Stage 03: Report to the Authority

National Electricity Transmission System Security
and Quality of Supply Standards (NETS SQSS)

GSR025: Updating the SQSS to reflect the recent modification to Engineering Recommendation P28

GSR025 Report to
Authority

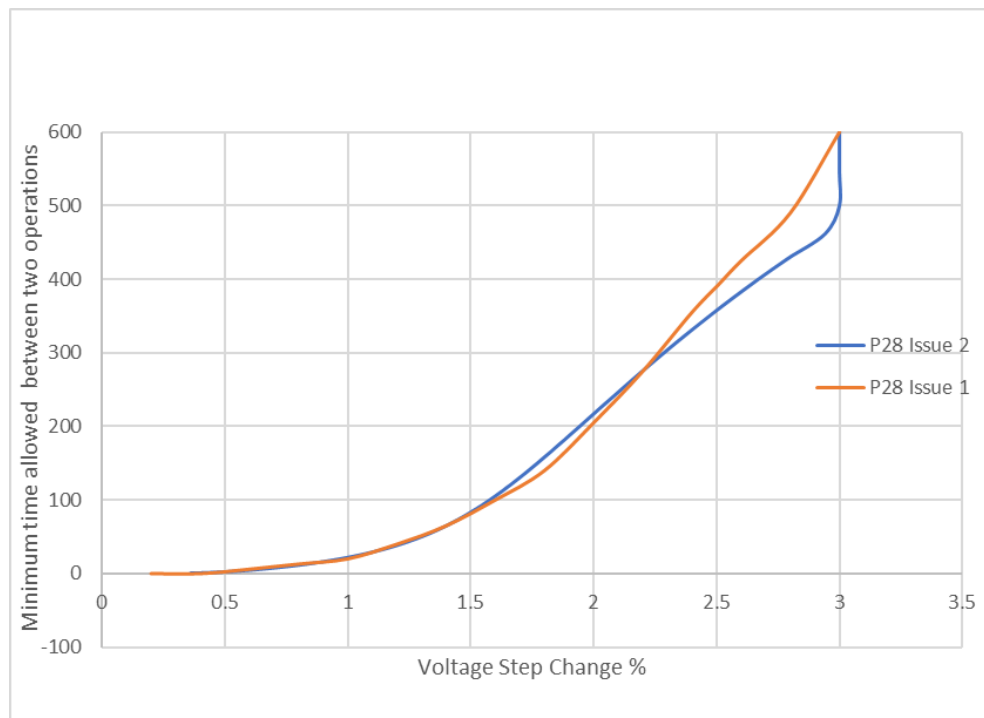
- 1.10 Therefore, a sequential modification is required to the SQSS to update the reference to the minimum time interval between voltage changes in Table 6.5 and to change Figure 6. which has been updated in Issue 2 of P28. It is proposed that the minor changes are made to Table 6.5 and a new diagram should replace Figure 6.1.

- 3.1 The minimum time required between two consecutive operations causing a Voltage Step Change of a specific level are shown in Figure 1 below for both P28 Issue 1 and Issue 2.

- 3.2 In order to reflect this change in the NETS SQSS it will be necessary to
- Change the 10 minutes referred to in Row 1 and Row 2 of Table 6.5 of the NETS SQSS to 8 minutes; and
 - Replace Figure 6.1 of the NETS SQSS by a new Figure 6.1 which is based on Figure B1.2 of the new EREC P28 Issue 2.
- 3.3 The changes arise as a consequence of the proposed change to Engineering Recommendation P28. The DCRP Consultation paper DCRP/PC/18/01 describes the proposed changes to Engineering Recommendation P28.

Figure 6.1 Maximum Voltage Step Changes Permitted for *Operational Switching*
derived from ER P28 B.1.2

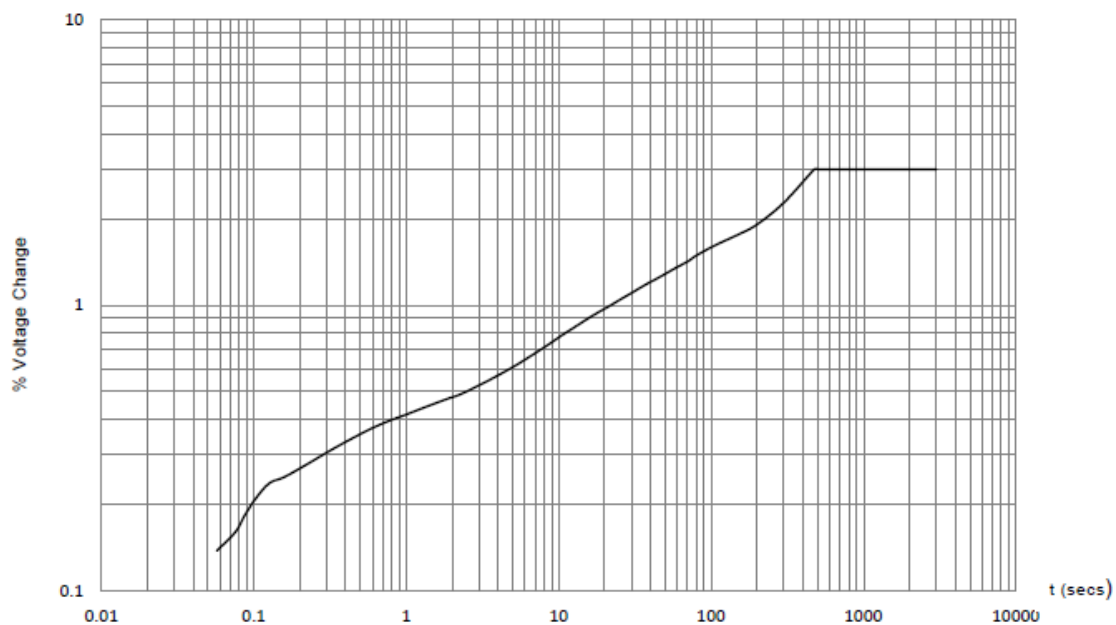
- 4.1 GSR0 requires amendments to the following parts of the NETS SQSS:
- Figure 6.1: Maximum Voltage Step Changes Permitted for Operational Switching
 - Table 6.5: Voltage Step Change Limits in Planning and Operational Timescales
- 4.2 The text required to give effect to this proposal is contained in Annex 1 of this Industry Consultation document.

2. Do you agree that Figure 6.1 should be updated instead of removed?	<i>Yes, though the inclusion of the figure may require further SQSS modifications should P28 be updated in the future, this prevents needing to refer to the source document when reading the SQSS.</i>
